INDEPENDENT EXPERT ADVISORY PANEL FOR MINING

***Metropolitan Coal Mine:
Independent review of environmental
performance to 2022
(Dupen, 2023)***

Report No: IEAPM 202309-2

Figure 1: Reproduction of Figure 1 of the Dupen Report in which it is captioned as *Key features discussed in this report, annotated in green over base figure reproduced from Metropolitan Coal 2021 Annual Report*, with the blue text boxes being added by the Panel.

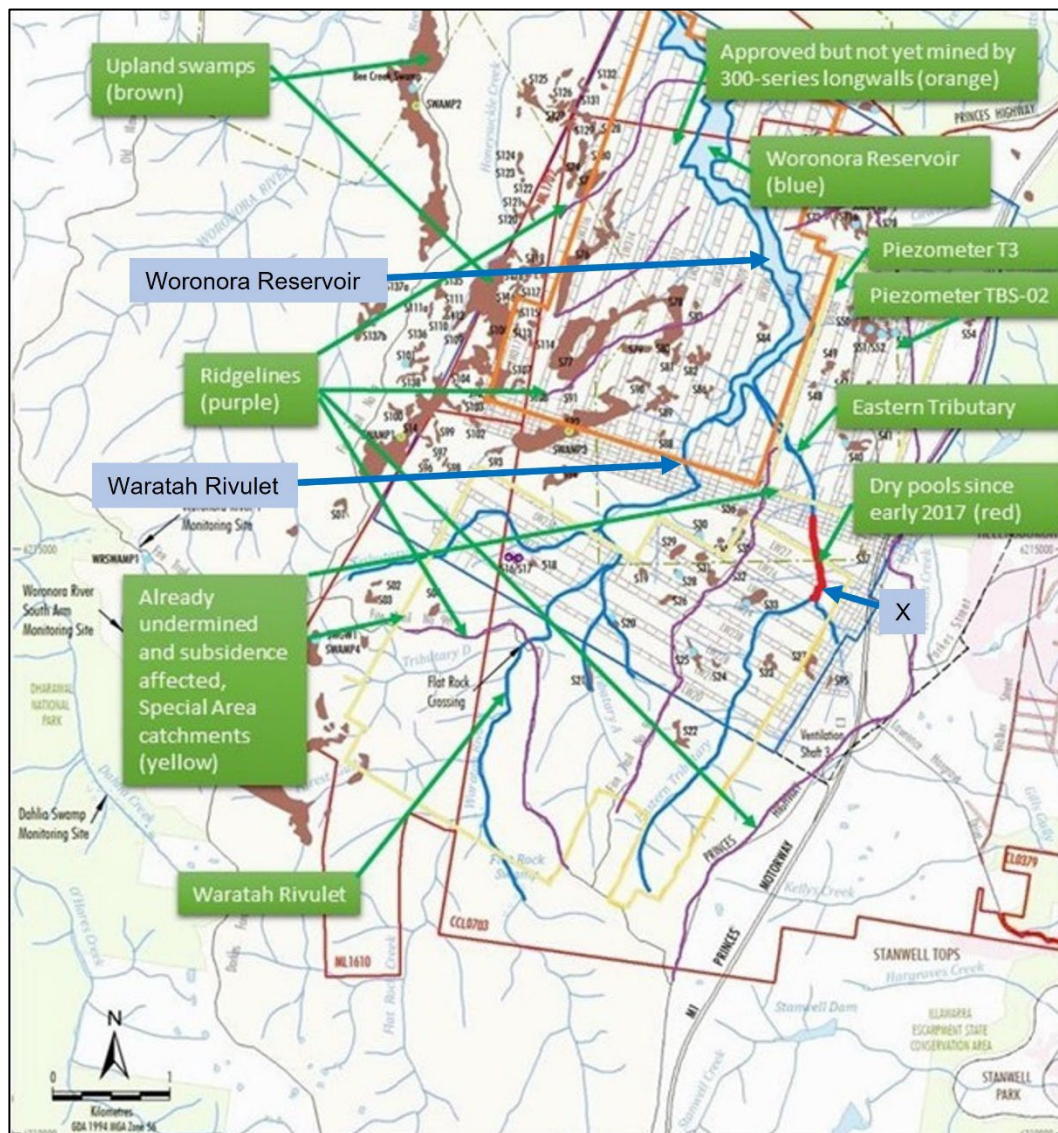
The Dupen Report proposes that the drying of pools over a 500 m length of the Eastern Tributary (Figure 1) supports the ridge fracture drainage hypothesis²⁹. This is based on the concept in Figure 6 that water is diverted from the ridges and hillsides through vertical fractures and shear planes into the fractured zone below the creek. The Report includes the statements *‘This evidence includes the unpredicted drying of all pools along a partly undermined section of Eastern Tributary’*³⁰ and *‘Since 2017, the previously permanent Pools ETAG to ETAR (Figure 11) have been dry except for short periods following major rainfall events’*³¹.

Contrary to Peabody's interpretation, my conclusion from the review reported herein is that a diversion of around 500 m of virtually all surface water flows via subsurface channels (Figure 1) constitutes more than a negligible environmental consequence, and therefore an exceedance of the Performance Measure

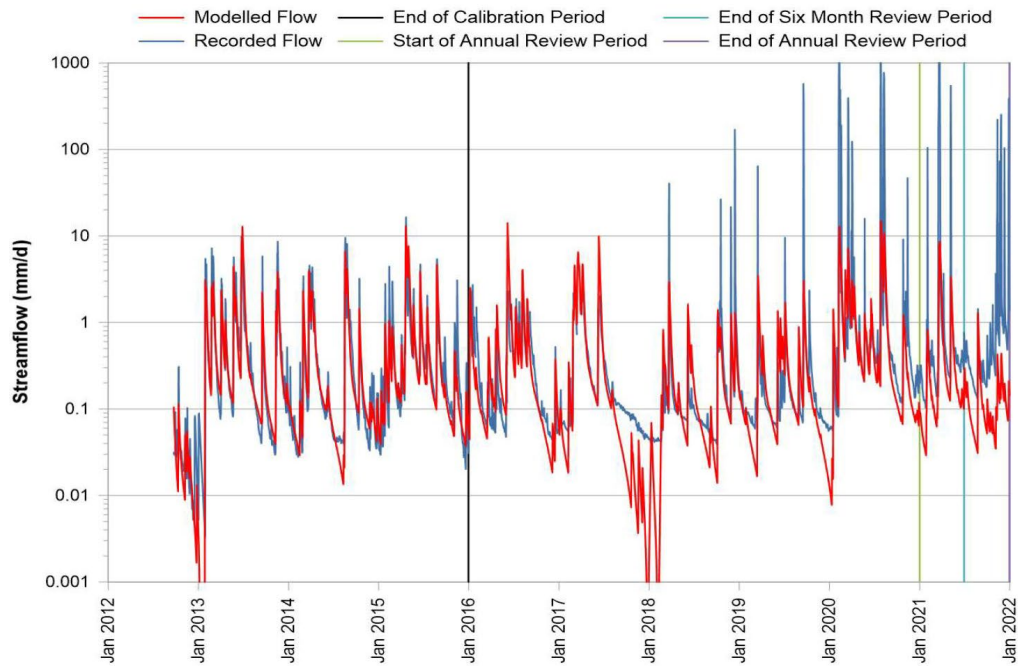
Dupen suggests that the anomalously high flows recently measured at the Eastern Tributary gauge (see Figure 3) may be explained by the Dupen Report's main hypothesis, being:

For high flows, from January 2019, Figure 3 includes several incidences of the flow rate measured at the Eastern Tributary weir being well above the rainfall rate at the nearby Darkes Forest gauge, Figure 12, which is implausible.²⁷ Following Metropolitan Coal's investigation into the flow anomalies (HEC, 2022), the rating curve (i.e. the calibration of the flow-depth relation at the flow measurement flume and weir) was updated to give the data in Peabody (2022b) reproduced as Figure 13 in this advice report. Figure 14 (Figure 8 from HEC, 2022) is the same plot, zooming in on the period 1-Jan-2020 to 1-Sept-2022.

The Panel does not agree with the reasoning presented by Dupen because the comparisons of catchment flow responses in his Figure 12, reproduced as Figure 3 of this advice report, are based on observed and modelled daily flows. The modelled flows are derived using the Australian Water Balance Model (AWBM), which is a spatially lumped catchment model. Neither this model nor the use of daily flows are designed to simulate local (500 m scale) effects on flow travel times, and so Figure 12 in the Dupen Report should not be used to support or challenge the “tunnel” concept. The Report goes on to state *“I also struggle to identify a plausible mechanism for the increasing flows observed since about October 2021 using this conceptual model”*. While other mechanisms can be identified to explain the increasing flows, no mechanism has been validated to explain the increased flows at this stage. The increased flows need to be better understood, as has been partly addressed by HEC (2022) and commented on by the Panel in Section 5.2.2.

Figure 4: Piezometric data for Boreholes T1 to T6 extending from the reservoir along a transect approximately at right angles to the reservoir. (Reproduction of Figure 9 in the Dupen Report)³

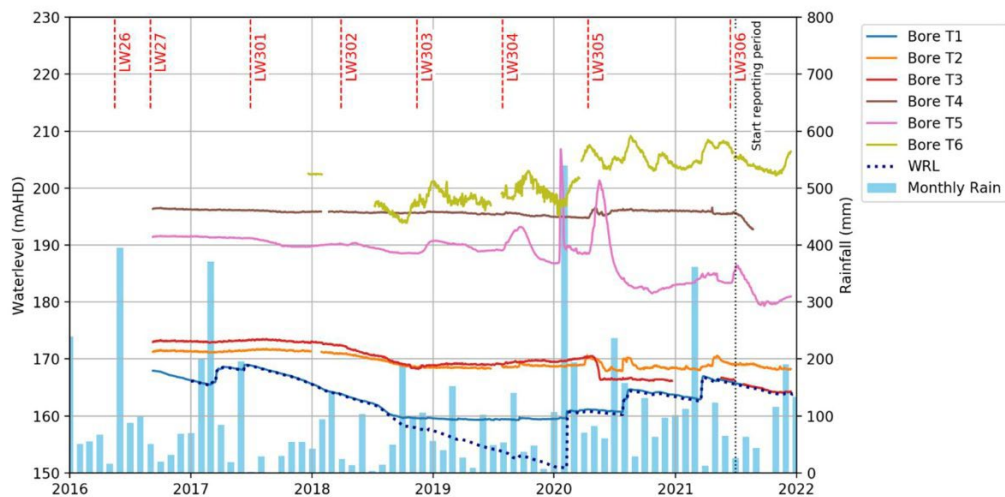
The most disturbing trend however, is that the levels in T3 dropped below its base 17 days after the commencement of Longwall 305 (Figure 3), and then sheared in December 2020 (Figure 9). The piezometer was replaced in 2021 by a deeper one at the same location (T3-R). As can be observed by the red trace in Figure 9, groundwater responses in T3/T3-R appeared sensible for its ridge position prior to mining but now the water table closely mimics the reservoir level.

Figure 6. Reproduction of Figure 4 of the Dupen Report where it is described as *Schematic showing the hypothesised causes of “ridge fracture drainage”, annotated here as basal shear planes (yellow) and sub-vertical stress relief fractures (grey).* Base figure reproduced from *Advisian, 2016*

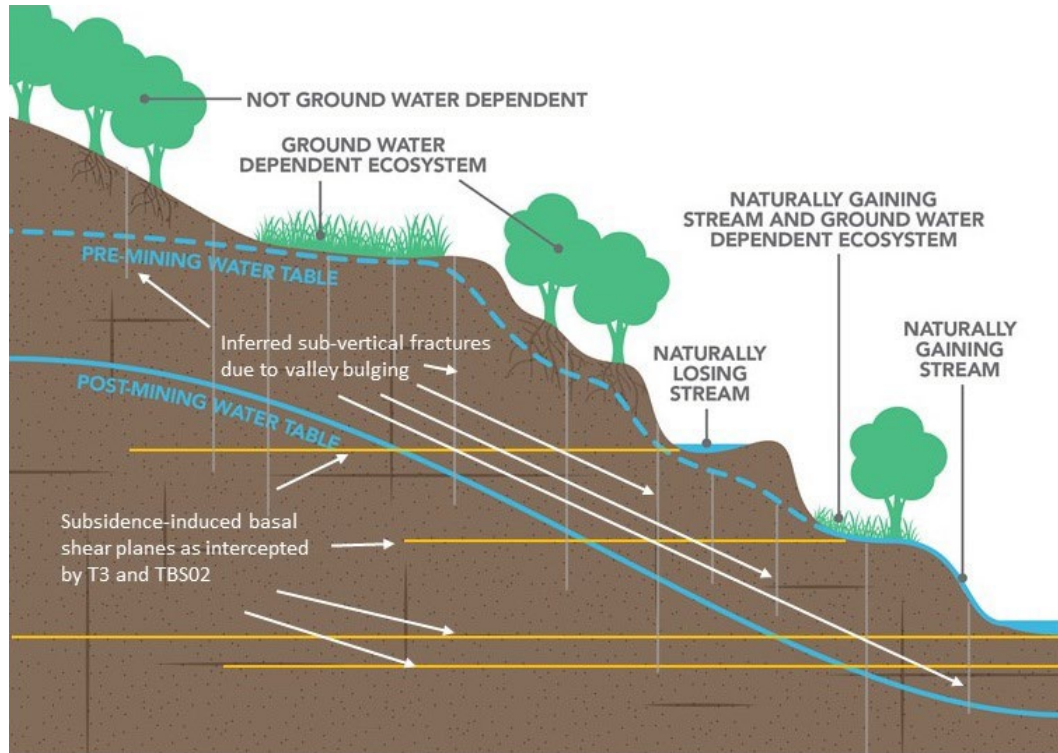
Figure 4 of the Dupen Report (reproduced as Figure 6 of this advice report) is a schematic that represents most of the perched and regional groundwater flow and discharge processes that occur in the Hawkesbury Sandstone landscape across the Southern Coalfields. However, the schematic is not representative of the specific groundwater processes that are occurring in the Eastern Tributary catchment. The schematic shows:

The caption to Figure 4 of Dupen (2023) refers to the inferred sub-vertical fractures as being *stress relief fractures*. As the valley sides are not subjected to lateral stress, stress relief is not a plausible mechanism for inducing vertical cracking. However, sub-vertical fracturing can be associated with conventional subsidence (subsidence troughs) and with unravelling of slope material caused by subsidence movement, although these fractures tend to close. This is because surface alluvium and rock displace downhill under the effect of gravity, resulting in tensile strains accumulating towards ridge tops and being expressed as wide, open cracks. For example, Galvin (2005) reported the presence of a +200 mm wide crack on a fire trail at the top of the ridge above Waratah Rivulet.

Against this background, subsidence can be expected to increase the capacity of the surface to absorb rainfall, however, the distributions and depth of the inferred subvertical fracturing shown in Figure 4 of the Dupen Report (Figure 6 of this Panel Advice report) is considered highly conceptual and very unlikely to represent the situation in the field.

Figure 4 in the Dupen Report, reproduced as Figure 6 of this advice report, and associated explanations in Sections 3.2 and 3.3 of the Dupen Report are an over-simplification of the groundwater flow processes in the Waratah Rivulet and Eastern Tributary catchments.

Figure 9: Profiles of predicted valley closure along the Eastern Tributary associated with both the mine layout proposed in the EIS for the Metropolitan Coal Project and the modified layout presented to the PAC during its assessment process (Peabody, 2009).

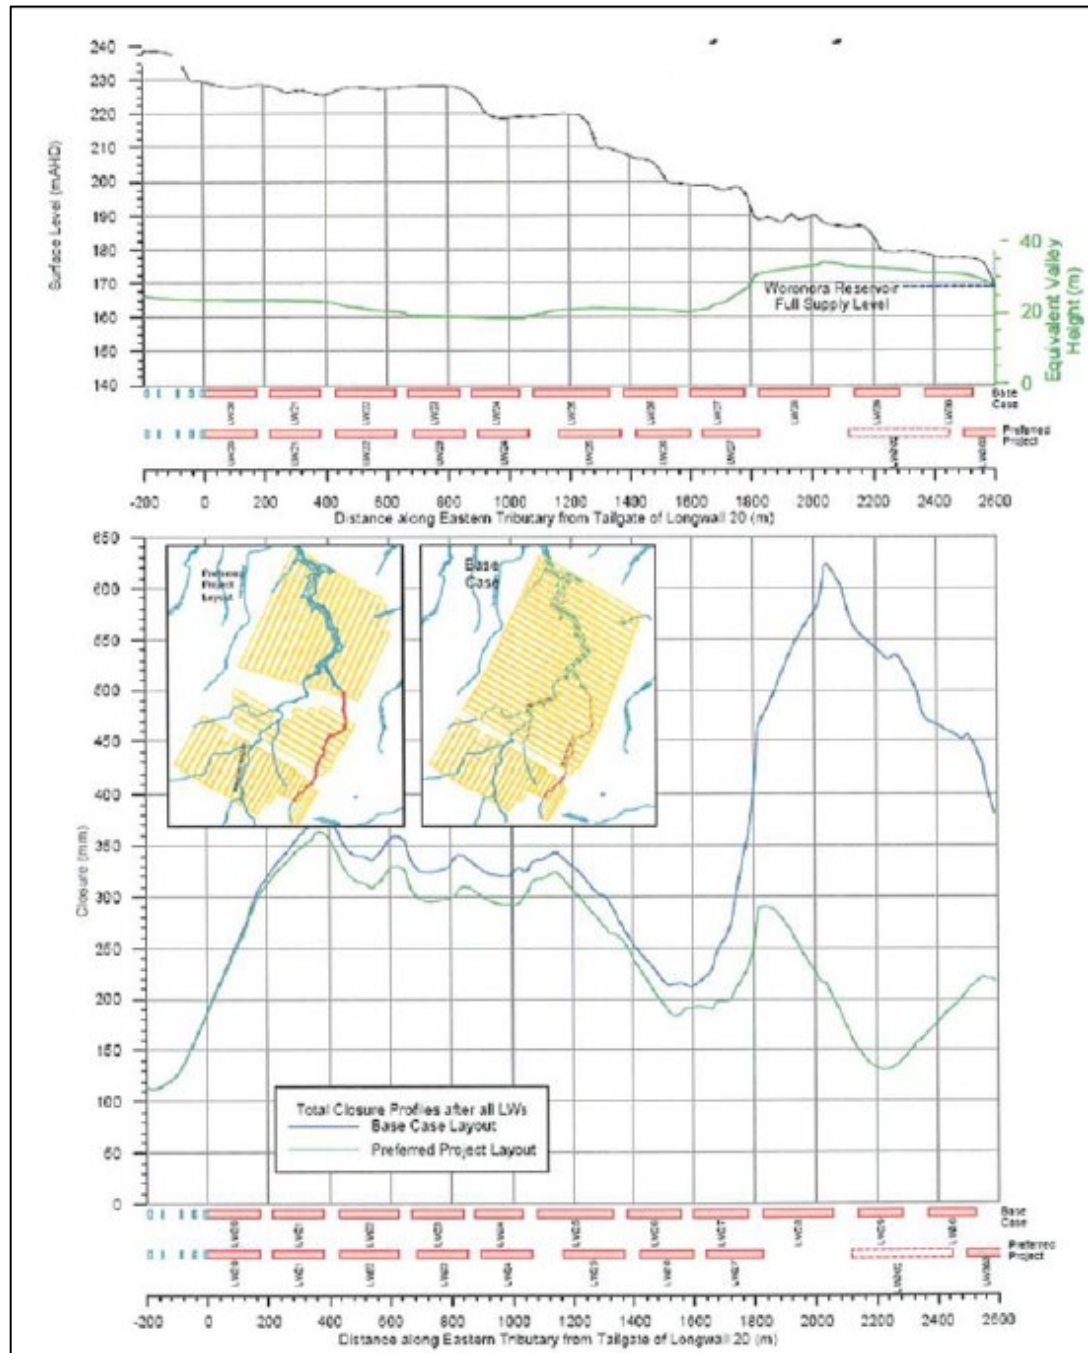
The revised mine layout was based on limiting predicted valley closure along Waratah Rivulet to less than 200 mm. However, this in turn did result in a reduction in predicted valley closure along the Eastern Tributary, as shown in Figure 9.

An expanded version of the PPR was submitted to the Department of Planning (DoP) after the PAC had concluded its review (as reported in the Department's 'Reasons for Approval'). However, the mine plan and predictions of valley closure were basically unchanged from that shown in Figure 9. DoP stated in its assessment of the PPR that:

The Panel is unaware of the basis for determining a figure of 70% and what sections of the Eastern Tributary downstream of the maingate of LW26 were expected make up this accumulated proportion of unimpacted stream length.

Figure 10: Predicted cumulative valley closure at the Eastern Tributary for LW302 to LW308 (Peabody, 2019).

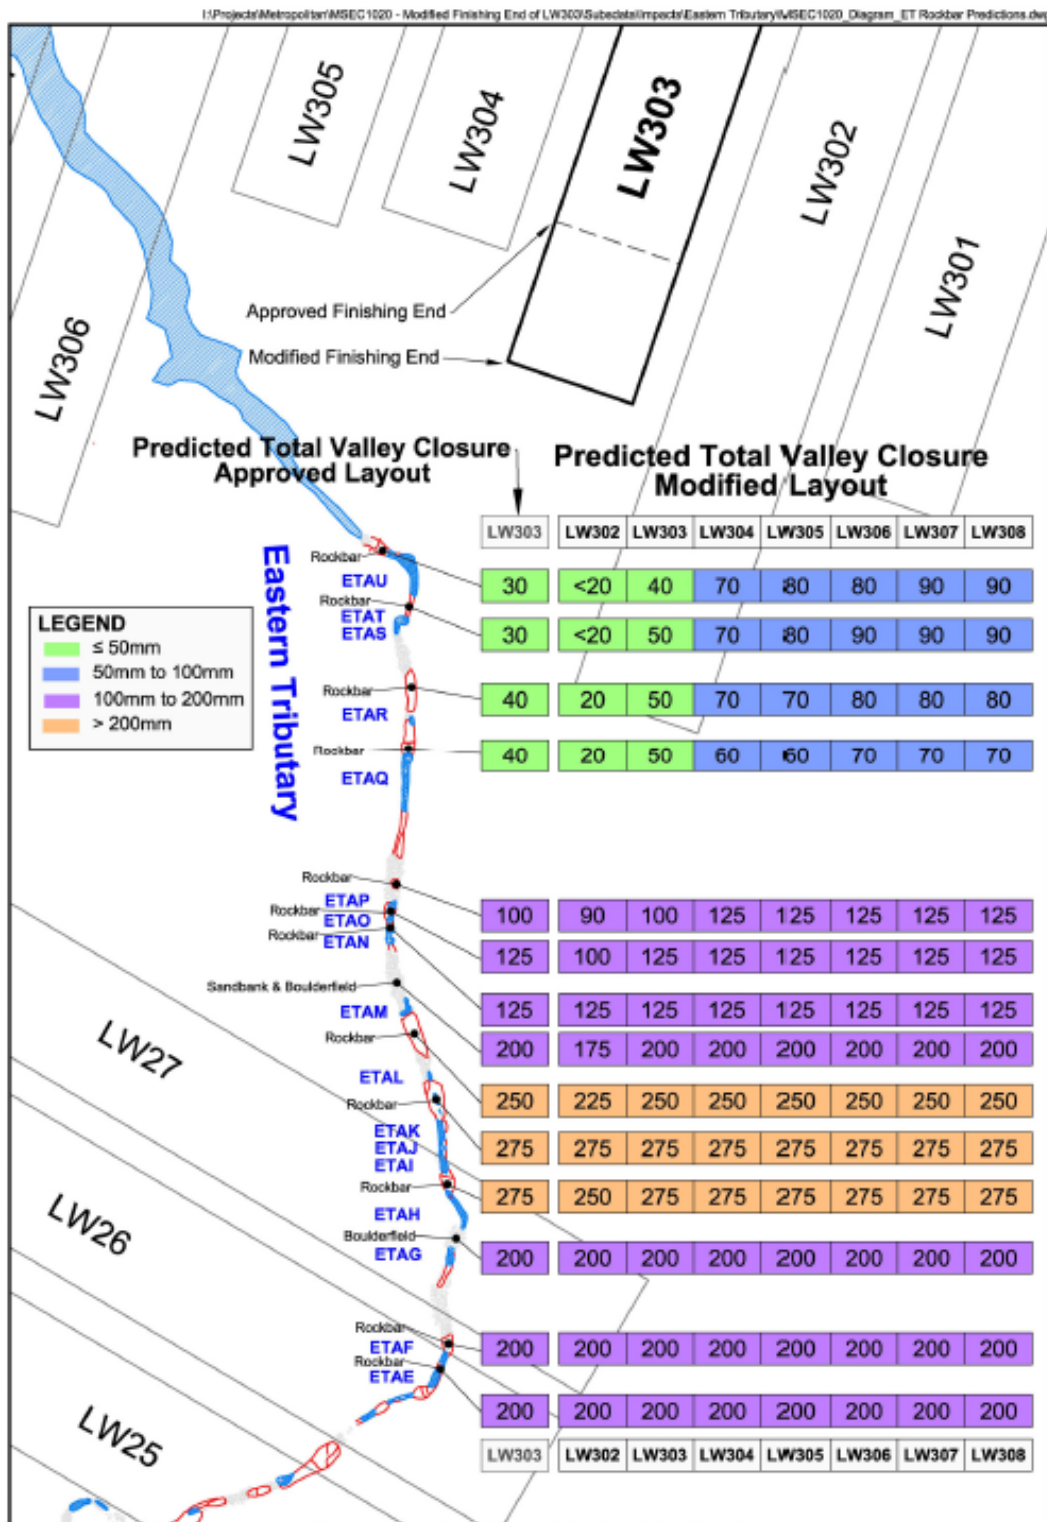
LW27 was completed in March 2017 and mining of LW301 commenced in June 2017. This panel was shortened for operational reasons and, as shown in Figure 10, stopped over 350 m short of its planned finish point. Hence, the contribution of this panel to cumulative valley closure along the Eastern Tributary could be expected to be minimal. LW302 was extracted to its originally planned and finished in February 2018. Soon after, it was recognised that the Performance Measure of negligible for 70% of the length of Eastern Tributary downstream of Point X had been exceeded, resulting in LW303 to LW305 being setback from Eastern Tributary substantially greater distances than planned at the time of project approval. The modified layout, shown in Figure 10, resulted in moderate to very large decreases in predicted valley closure downstream of about pool ETAM²⁵, as evidenced by comparing predictions plotted (in green) in Figure 9 with those tabulated in Figure 10.

The Panel notes that the Eastern Tributary was undermined by LW27 in November and December 2017 and remained within the area of influence of active mining until the panel was completed in March 2017. The tabulations of predicted valley closure presented in Figure 10 show that after the completion of LW302, predicted valley closure plateaued at 200 mm on the southern flank and at the centre of LW27 and at 275 mm on the northern flank of LW27 and downstream to rockbar ETAL. It then progressively reduced and plateaued at 200 mm at ETAM and 125 mm at ETAN, ETAO and ETAP.

Based on the predictions of valley closure for both the original approved mine layout and the actual mine layout, it appears likely that the extraction of subsequent longwalls after LW27 would have resulted in minimal additional (incremental) predicted valley closure at rockbars upstream from ETAP; that is, the values of predicted valley closure tabulated for these rockbars in Figure 10 are likely to be close to those at the time that the Eastern Tributary was being undermined by LW27. This being the case and given the magnitudes of the predicted cumulative valley closures at that stage, it is quite plausible that the incremental increase in valley closure over not only LW27 but also over previously extracted longwalls in its vicinity was a trigger for a significant mining-induced ground deformation event beneath the Eastern Tributary, at least downstream to ETAP.

Figure 13: Flow data from the Eastern Tributary gauge. Originally Chart 4 in Peabody (2023). (The y-axis scale (mm/day) is the flow volume rate in mm^3/day divided by the catchment area in mm^2 . $1 \text{ mm/day} = 67 \text{ L/s}$.)

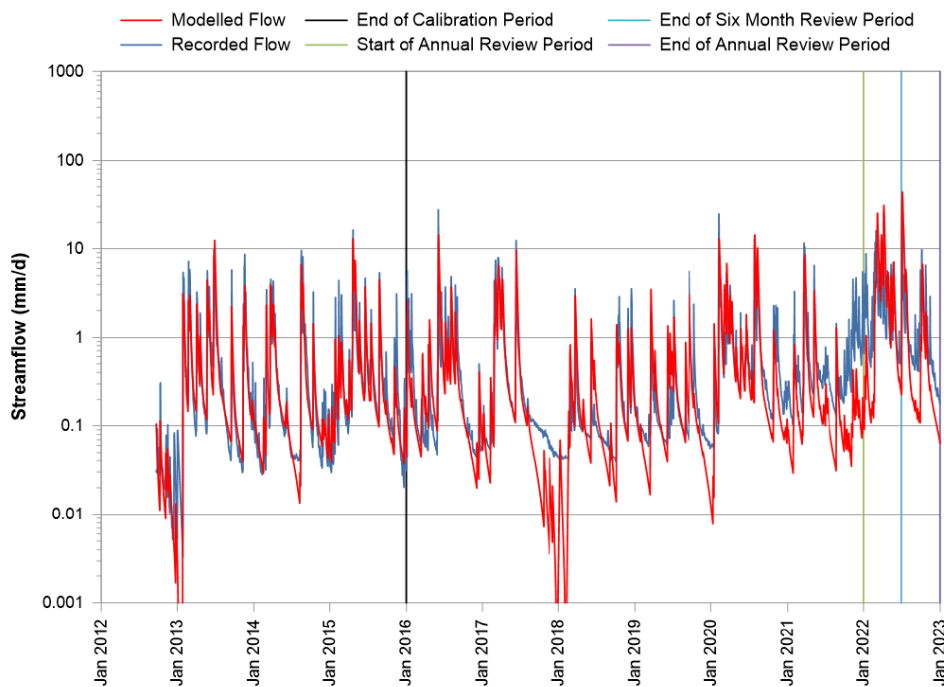
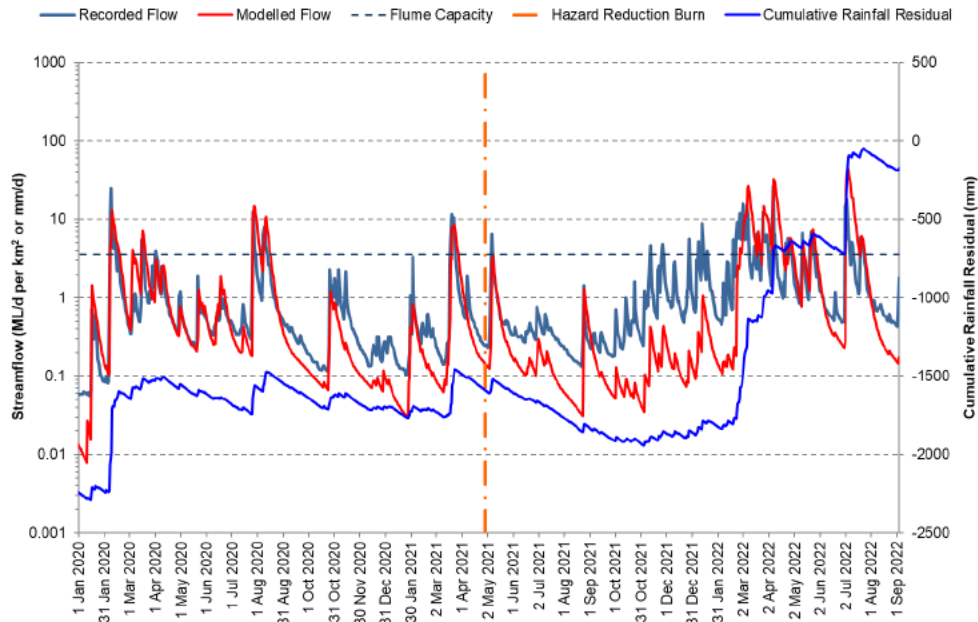
3. The substantially increased flows since August 2020, which is before the burn event, suggest larger volumes of groundwater release following rainfall events. Higher infiltration rates would be reflected in increased interflow volumes and potentially increased regional groundwater levels and discharges. While the AWBM model used to produce the red lines in Figure 13 and Figure 14 will translate high rainfall to groundwater storage and flows, it is possible there are non-linear responses to high rainfall that the model does not account for, which could create the flow anomalies in Figure 13 and Figure 14.

Regarding the timing of the flow anomaly in relation to mining, the clear flow anomaly in Figure 13 and Figure 14 begins in August 2020, whereas mining of LW27 ceased in early 2017, so it seems unlikely that this change in flow response is associated with basal shear plane movement as a result of mining, unless this happened during the 300 longwall series. Predicted valley closure due to cumulative effects of LW302 to LW308 are shown in Figure 10. This shows a small increase in predicted closure from rockbars ETAU to ETAM due to the extraction of LW302 and LW303, being a maximum 25 mm in the vicinity of ETAM. Subsequent longwalls do not result in any increases in predicted valley closure. Where there are closure increments due to LW302 and LW303, it is only in the vicinity of ETAM that the predicted cumulative closure reaches above 125 mm. The Panel concludes it is conceivable but unlikely that ground movements upstream of the Eastern Tributary flow gauge since 2017 were significant enough to increase hydraulic conductivity of shear planes. The Panel recommends that available measurements and predictions of ground movements due to the 300 series of longwalls, including measured valley closures, are reviewed to determine if ground deformation might be responsible for changes in flow responses observed since August 2020.

The unexpected increase in flows that is seen in Figure 13 does not breach the quantity component of the performance measure “*negligible reduction in the quantity and quality of water resources reaching the Woronora Reservoir*” as the flows to the reservoir are higher than expected. The Dupen Report considers long term changes to the flows by suggesting that “*Once a new equilibrium is established, quicker and smaller baseflows may reduce overall flows to the Reservoir*”³⁴ but does not present the basis for this suggestion. The Panel agrees that the pattern of baseflows to Woronora Reservoir would change if the Dupen hypothesis is correct. This is because of the more rapid transit of water through the groundwater system leading to quicker rises and falls in the baseflow component of the reservoir inflows. However, the Panel does not agree with the suggestion that the baseflows would be smaller. The total volume of baseflow would only reduce if groundwater recharge is reduced or if groundwater is diverted out of the reservoir catchment. The Dupen Report identifies higher groundwater recharge conditions as “*stress relief fractures are expected to result in increased infiltration of rainfall runoff from undermined ridge surfaces and soil-rock interfaces*”³⁵. No mechanism is presented in the report that indicates that groundwater is likely to be diverted away from the reservoir catchment. In these circumstances, inflows to the reservoir are not expected to reduce unless the climate changes. This is contrary to Dupen’s assertion.
